AUTOMATIC TRANSMISSION SERVICE GROUP

"VOLUME II"

Since the introduction of the THM 440-T4 (4T60) Transaxle in April, 1984, there have been MANY major engineering design changes. These changes have affected nearly every part used in the THM 440-T4 (4T60).

This version, "VOLUME II", of the 440-T4 "Update Handbook" begins with the engineering design changes that occurred in the 1990 model year and will explain each change, the parts affected by the change, any parts interchange problems created by the change, and will be revised as necessary.

Figure 18

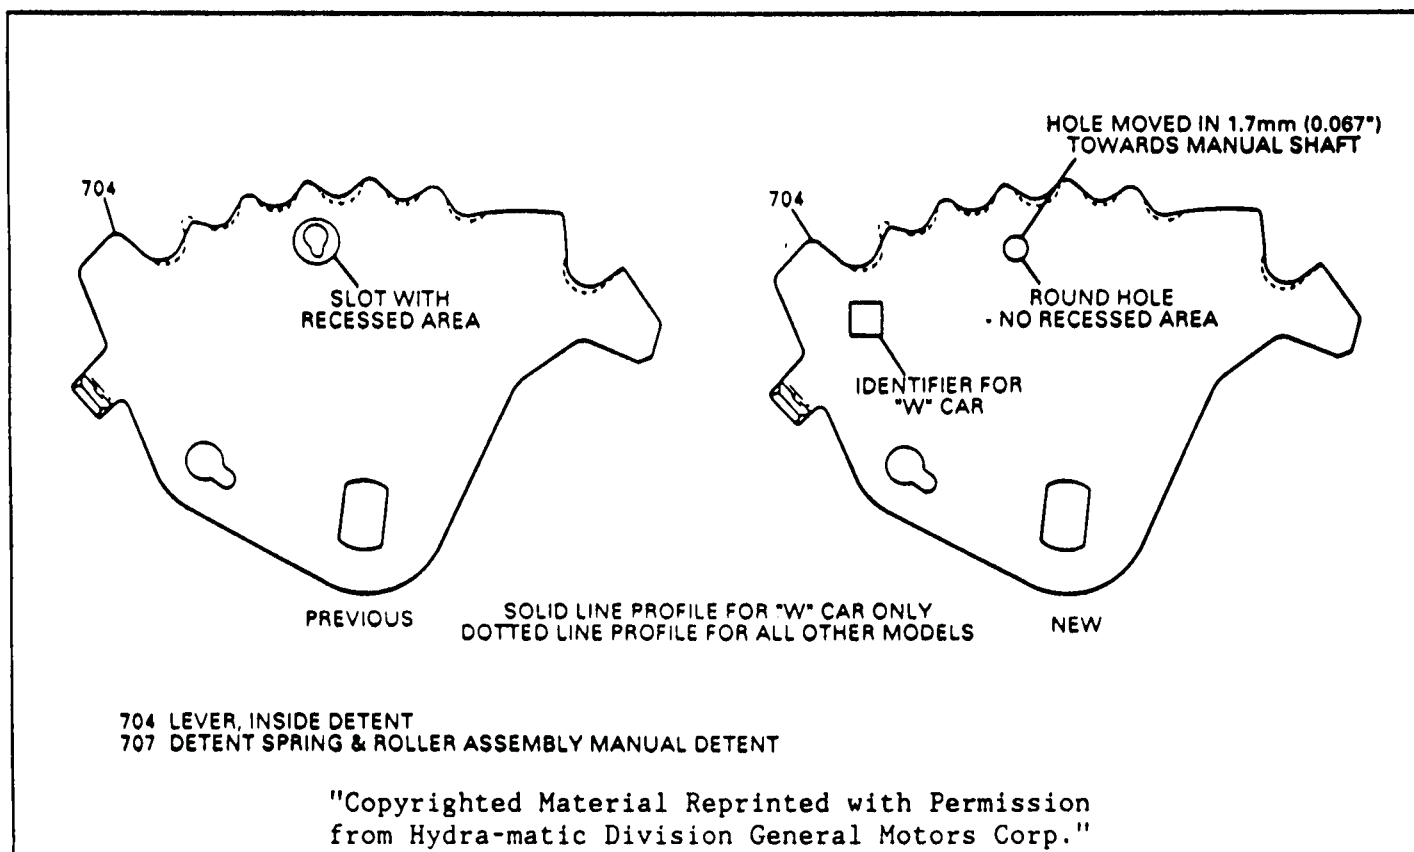
NEW INSIDE DETENT LEVER - Will have the manual link hole location changed to provide a different "Throw" of the manual valve, and the hole is now round instead of "Key Hole" shaped. Since the "W" car detent lever is different than all others, it will have a square identification hole punched in it. The previous and new inside detent levers will not interchange. See Figure 18 for identification.

Figure 19

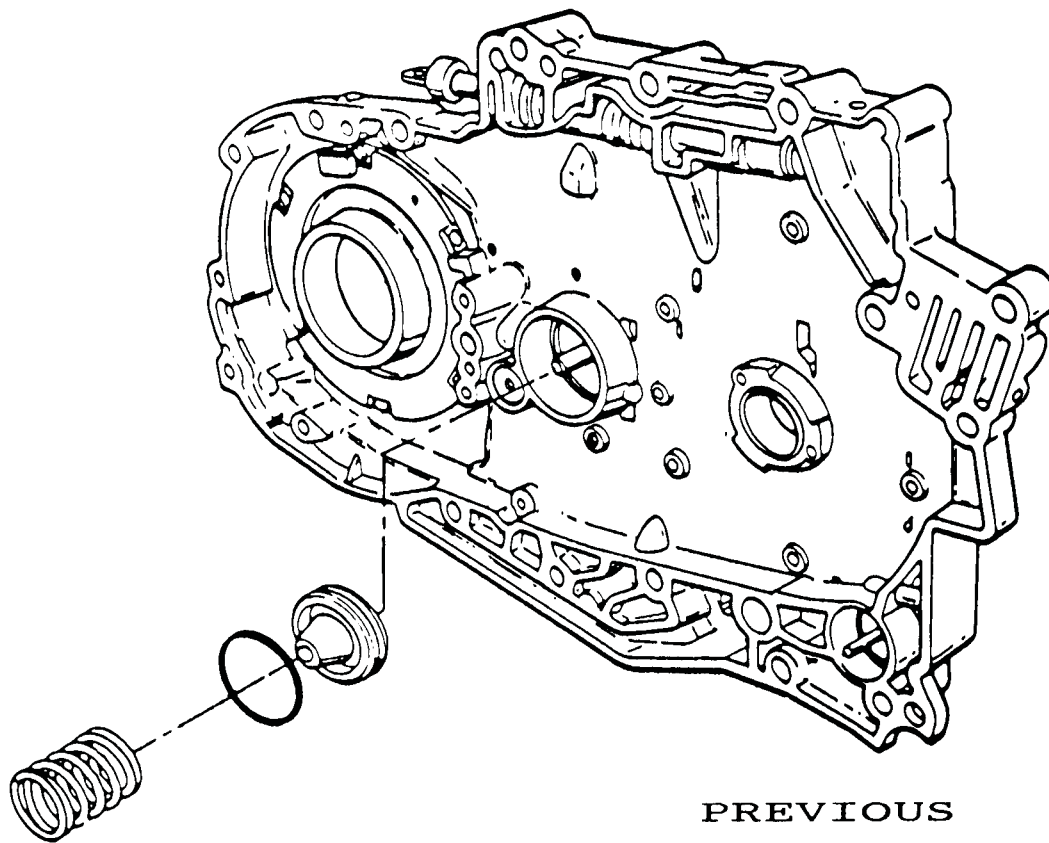
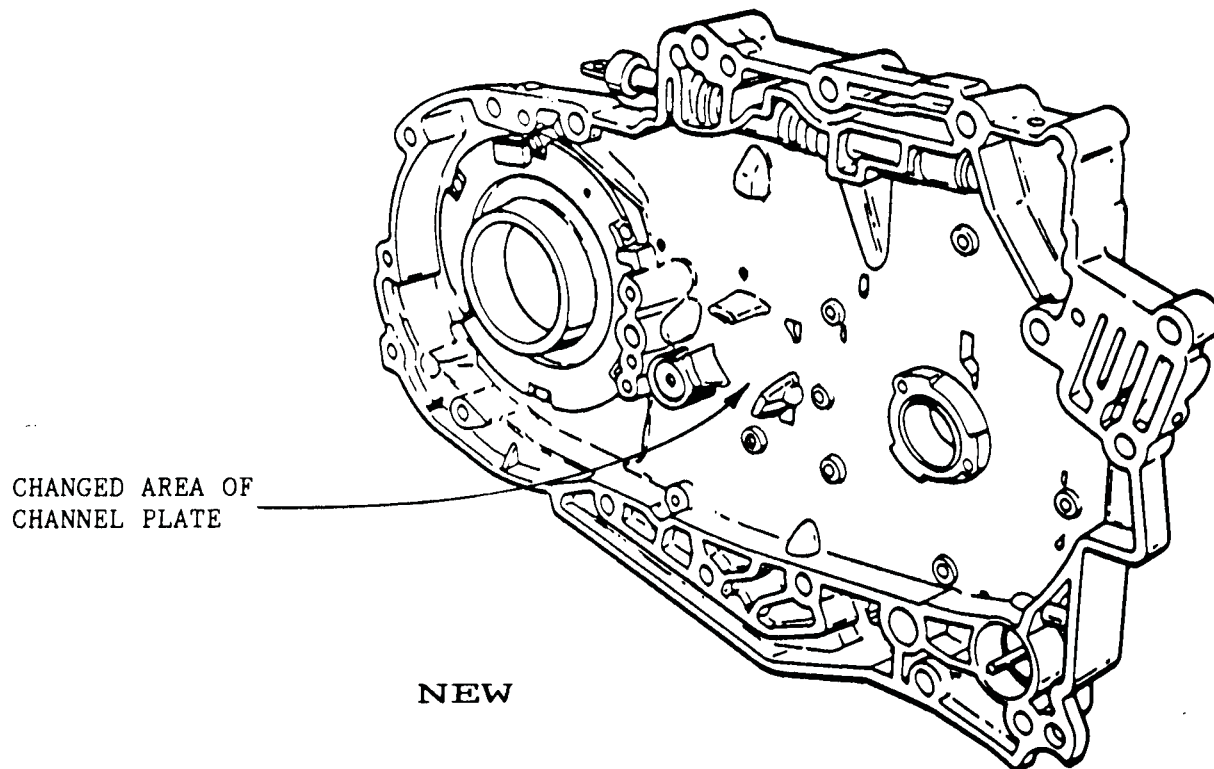
CHANGE: The Input Clutch Accumulator has been eliminated from the channel plate (See Figure 19).

- (1) CHANNEL PLATE - The input clutch accumulator piston, piston pin, and accumulator spring have been eliminated from the channel plate, which of course changes the channel plate casting (See Figure 19).
- (2) INPUT HOUSING - Top snap ring groove moves .060" closer to the top of the input housing, to accomodate the added wave plate (See Figure 20).
- (3) INPUT CLUTCH STEEL PLATES - The steel plates are .027" thinner to help accomodate the added wave plate (See Figure 21). The new steel plates are .049" thick, and the old steel plates are .076" thick (Figure 21).
- (4) INPUT CLUTCH "STACK-UP" - The input clutch stack has also been revised to accomodate the new changes. Refer to Figure 21 for proper assembly of the new input clutches.

NOT RECOMMENDED TO INTERCHANGE WITH PREVIOUS MODELS.

Figure 22

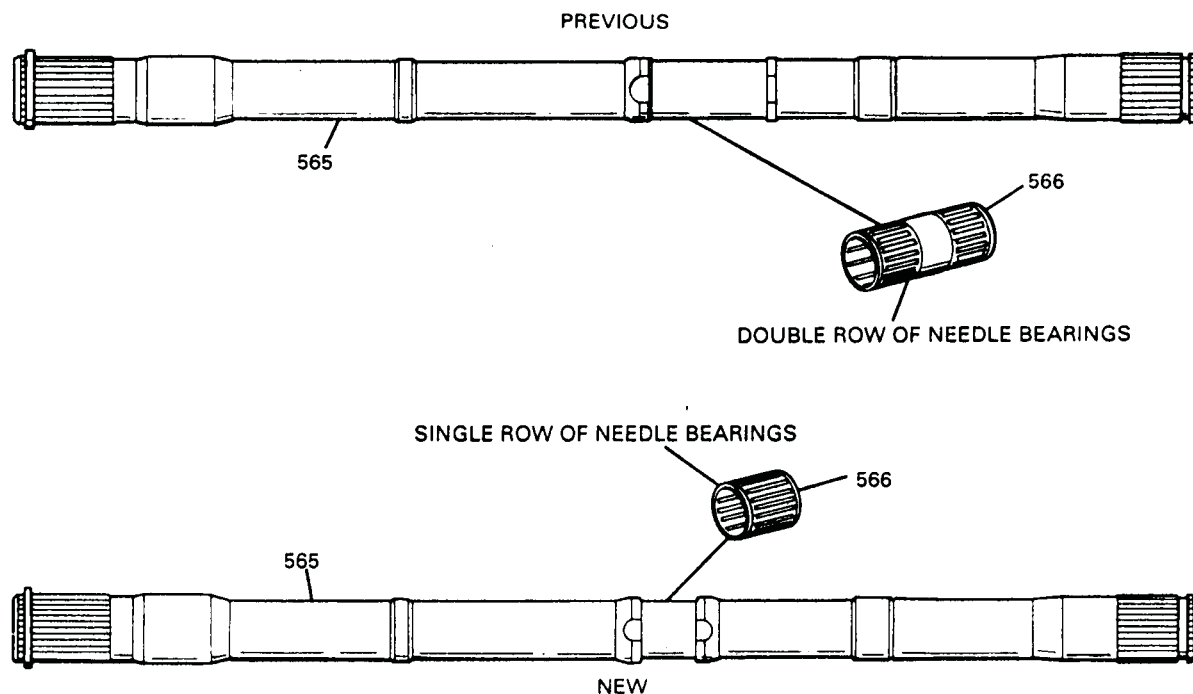
CHANGE: There is now a new Output Shaft/Bearing Assembly, and a new style (5th Design) 3rd Roller Clutch Assembly (See Figures 22 and 23). Beginning on December 11, 1989 (Julian Date 345) all 1990 model 440-T4 transaxles were built with the new 3rd Roller Clutch Assembly, and the new Output Shaft/Bearing Assembly went into production on January 25, 1990 (Julian Date 025).

- (1) **OUTPUT SHAFT/BEARING** - The new bearing has a single row of needle bearings instead of a double row, and the output shaft is machined different to accomodate the new bearing (See Figure 22). This change will improve lube oil flow to the 3rd roller clutch and input sprag.
- (2) **3RD ROLLER CLUTCH ASSEMBLY** - The new 3rd roller clutch outer race has four (4) less lube holes than previous models. The four lube oil holes are in line with the very end of the rollers (See Figure 23). Elimination of these four holes helps keep the rollers from "Skewing" (Running at an Angle), thus generating less heat.

The new Output Shaft/Bearing Assembly will retro-fit back to 1988 models ONLY, because the longer output shaft was required for the up-dated final drive assembly that had the larger side gears.
IT WILL NOT FIT INTO 84-87 MODEL TRANSAXLES.

Figure 24

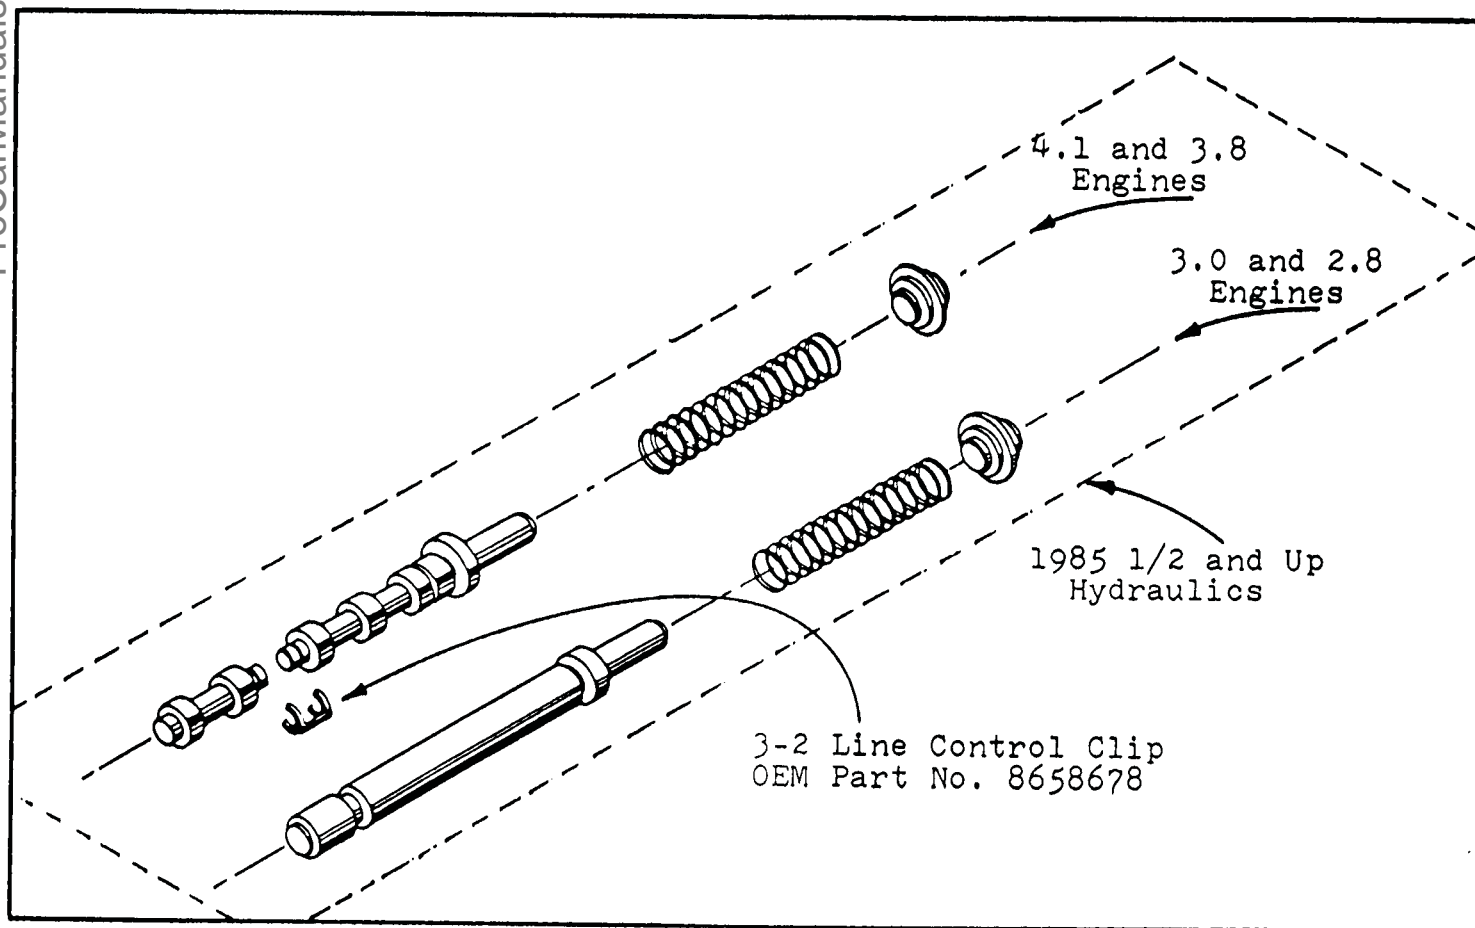
Proper spacer plate identification and selection is a MUST on the THM 440-T4. There are 2 different line-ups for the 3-2 line control valve, located in the channel plate, on all 1985 1/2 and later hydraulics. The 2 piece 3-2 line control valve is used on 4.1L and 4.5L Cadillac Engines, 3.8L Buick Engines, 3.3L Buick Engines, and 3.1L Turbocharged Engines (See Figures 24 and 25). The "Plug" that is also shown, is used on 3.1L Pontiac Engines, 3.0L Buick Engines, and 2.8L Chevrolet Engines (See Figures 24 and 25).

THESE SPACER PLATES WILL NOT INTERCHANGE

Figure 25

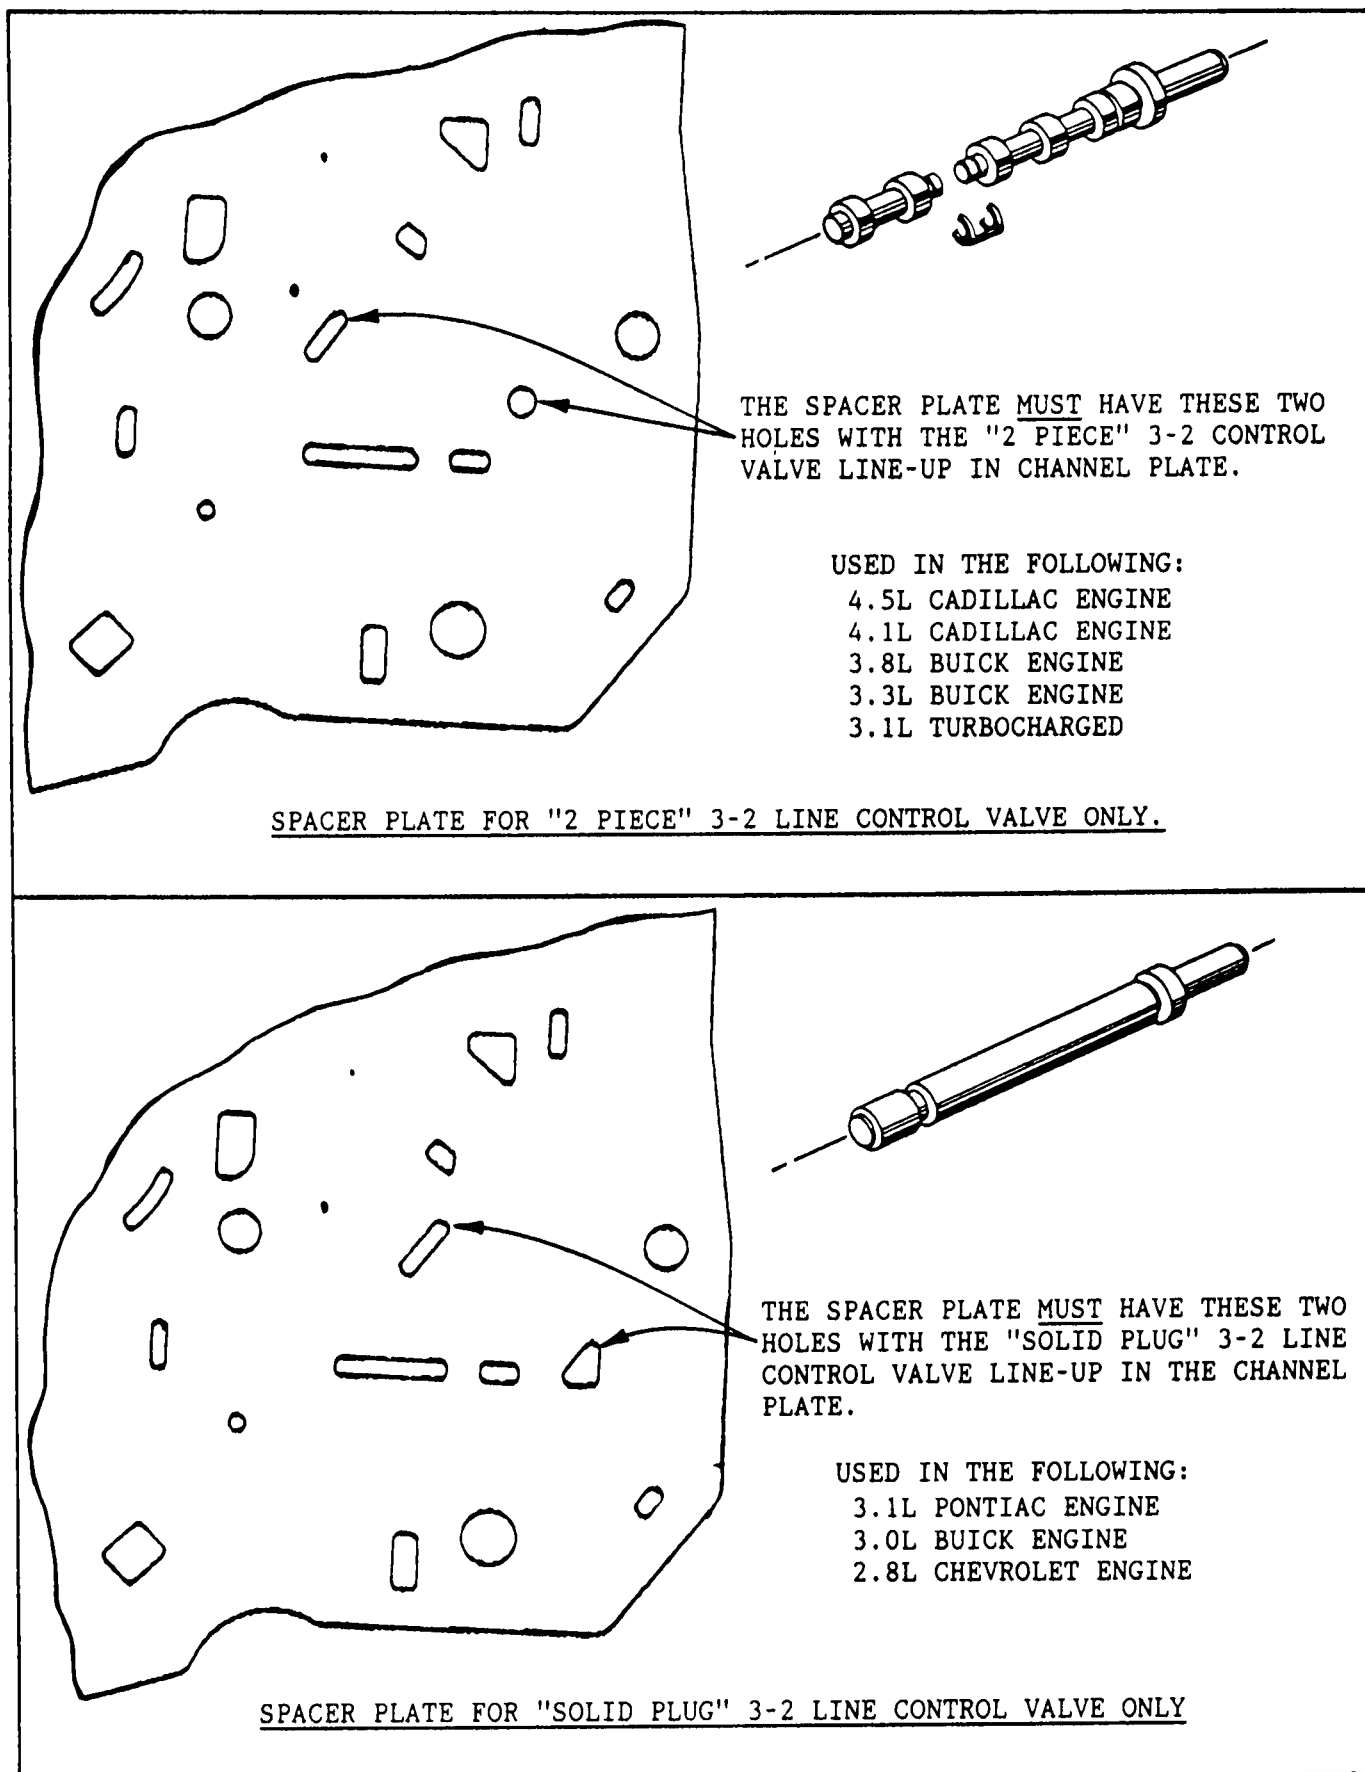
Refer to Figure 25 for the specific holes in the spacer plate to identify which valve line-up the spacer plate is compatible with.

Figure 26
AUTOMATIC TRANSMISSION SERVICE GROUP

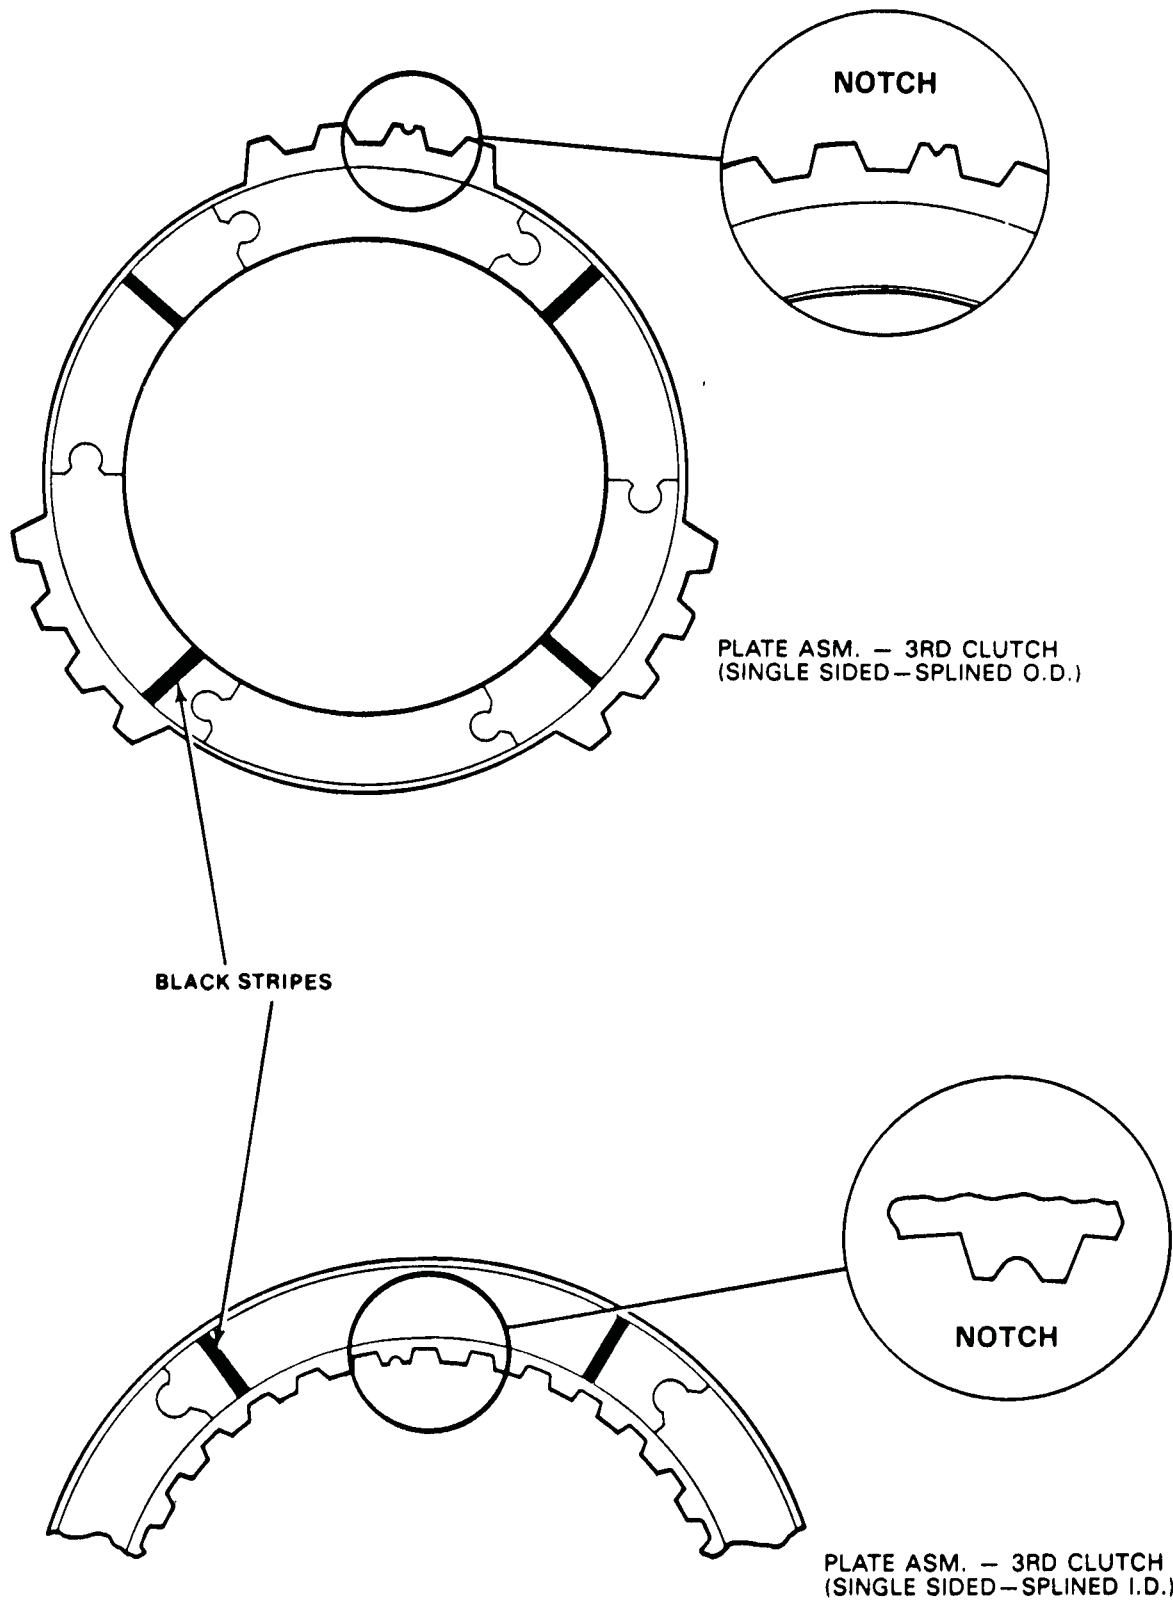
- (1) 3RD CLUTCH PLATES - Change of Fiber Material on the 3rd clutch plates, and can be identified by four (4) black stripes and/or "Notch" cut in one of the teeth, and/or NO identification at all (See Figure 26).
- (2) NEW MODEL CODES - Were assigned when the fiber material change on the 3rd clutch plates was put into production (See Figure 27).
- (3) SPACER PLATE - Was changed on some models. To identify the new spacer plate, see Figure 28 for numbers.
- (4) VALVE BODY CALIBRATION - Goes as follows: (Refer to Figure 29)
 - A. 2-3 accumulator valve spring (Most Models).
 - B. 3-2 control valve spring (All Models).
 - C. 1-2 accumulator valve spring (CPH Models Only).

The new 3rd clutch fiber plates (Black Stripe) WILL NOT service previous models, UNLESS, a Calibration Update Kit" is installed at the same time. When the new 3rd clutch plates and Calibration Update Kit are installed, a new model tag must be installed with adhesive, that reflects the "New" model code. This is supplied in the Calibration Update Kit. Refer to Figure 32 for location of I.D. tag.
